No. 1128
ATA Code 24-10

SUBJECT: ELECTRICAL POWER - INSTALLATION OF BUS BAR ON ALTERNATOR, BATTERY AND ENGINE GROUND CONNECTIONS

EFFECTIVITY: BEECHCRAFT Skipper 77, serials WA-1 through WA-90.

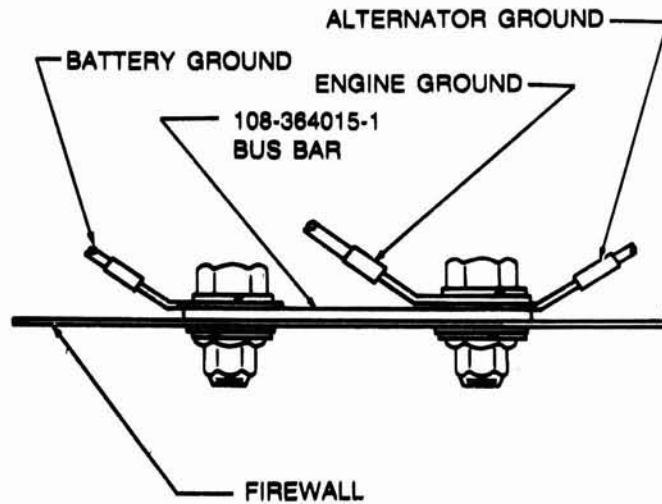
REASON: To minimize the possibility of overheating at the battery and engine grounding studs if a heavy starter load is experienced.

3. It will be necessary for one person to assist in the bolt removal from the inside of the airplane. Maintaining the relative position of the attaching hardware and wiring, pull the bolts away from the firewall and install the bus bar so that upon reinstallation the bus bar will be against the firewall as shown in the illustration.

The wiring is to be reinstalled in the same position as before removal.
